DOCUMENT - 2026-264T

**Interior and Exterior Renovations at Peel Regional Police 12 Division, 4600
Dixie Road, Mississauga**

ADDENDUM NO. 5

Panelboard PP0 Nameplate:

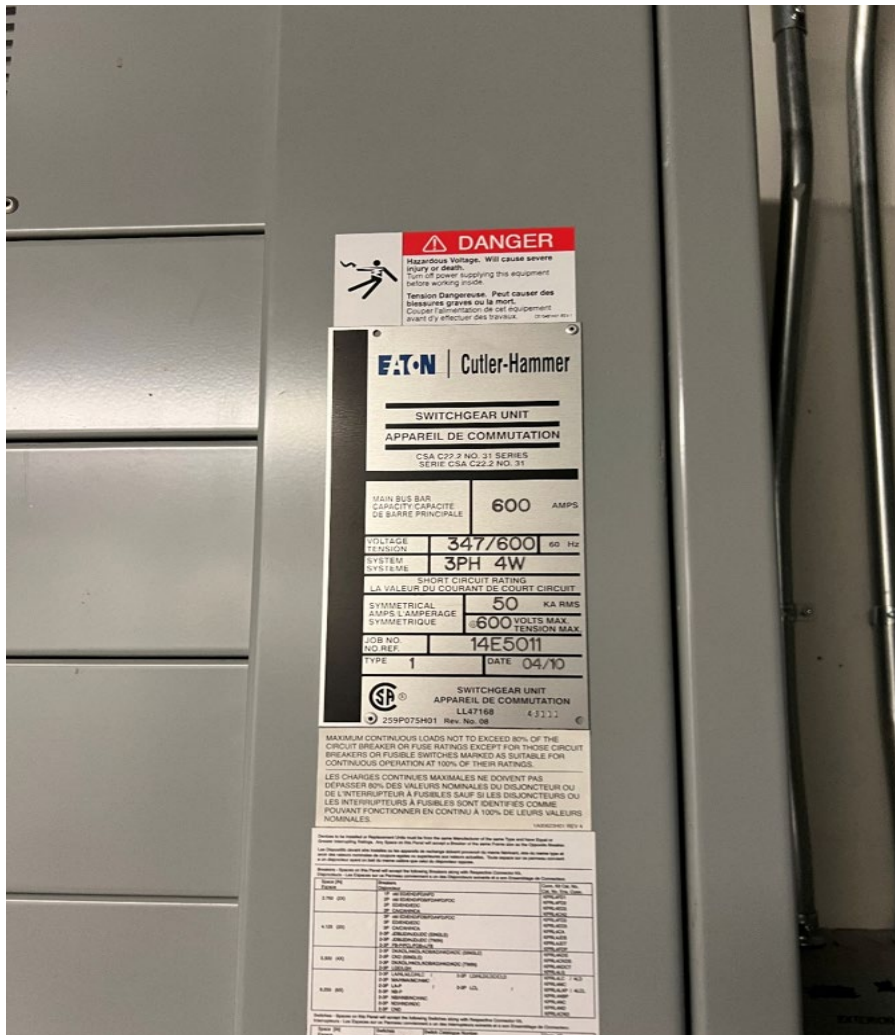
Could you please provide photos of the panel PP0 and any information showing the panel make/model? This will help us confirm the correct breaker type and ensure compatibility.

Panelboard PP0 Distribution Section:

RAMP SECTIONS

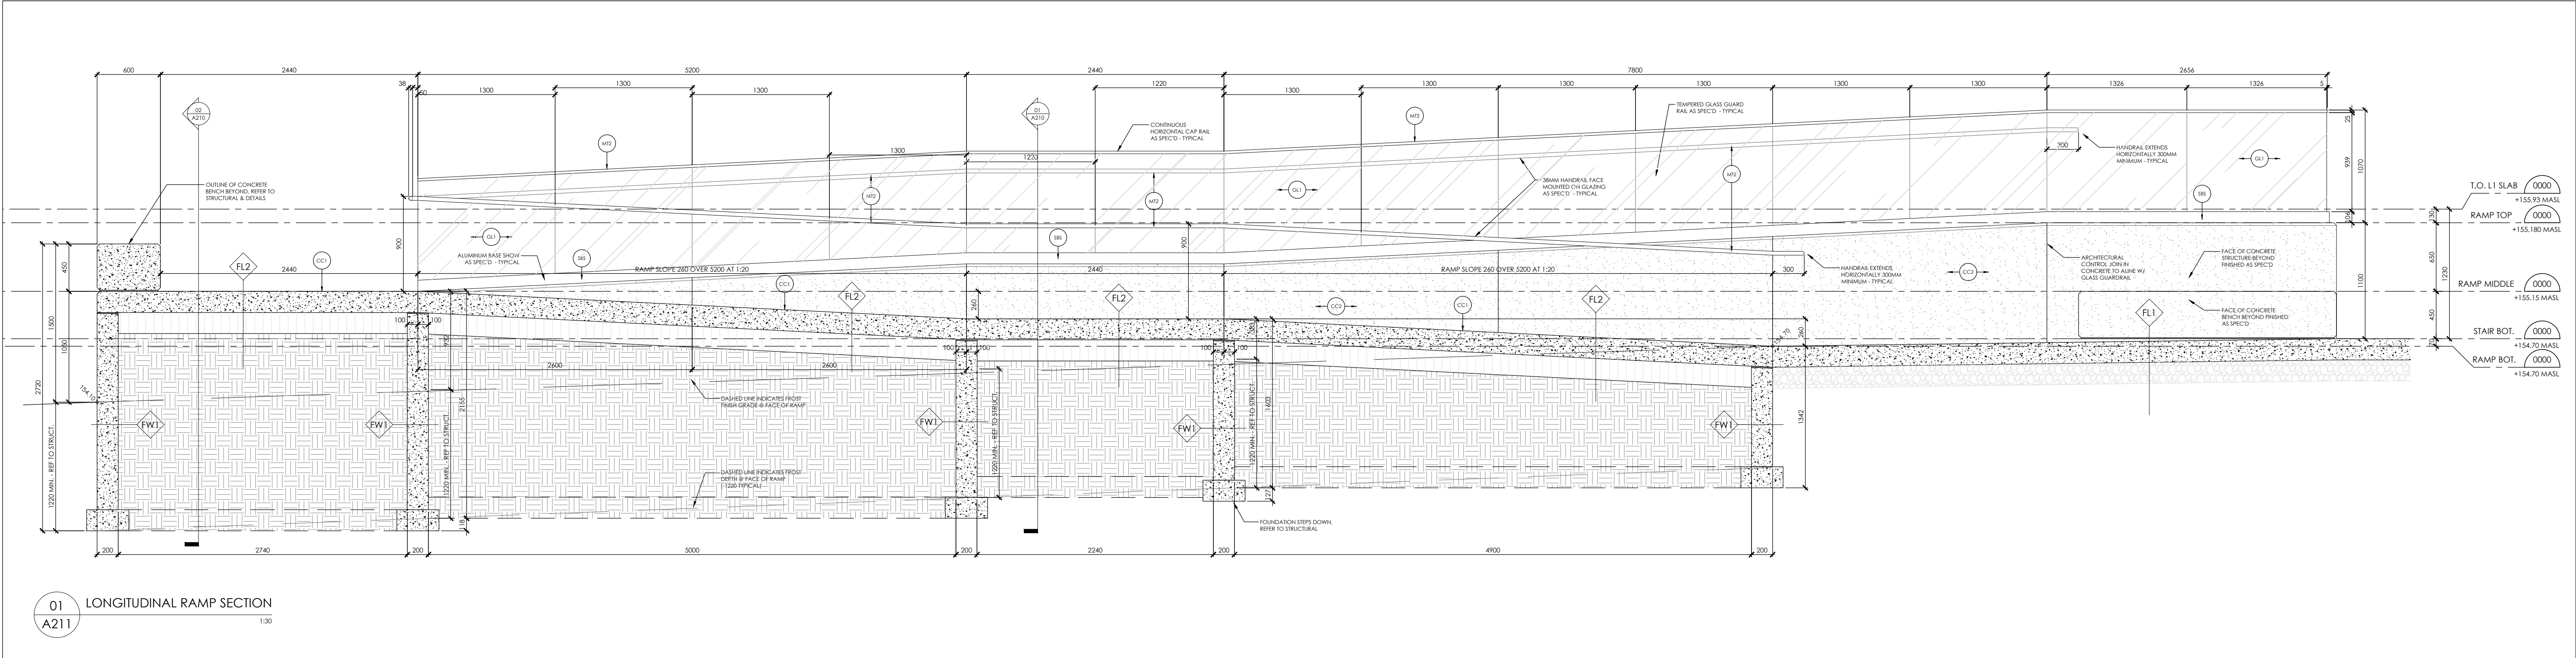
Please provide details of the cast in place concrete seating – note 01 on drawing A120.

Please refer to the attached updated section 01/A211 (1 page) and Structural Addendum SA-01 (3 pages).
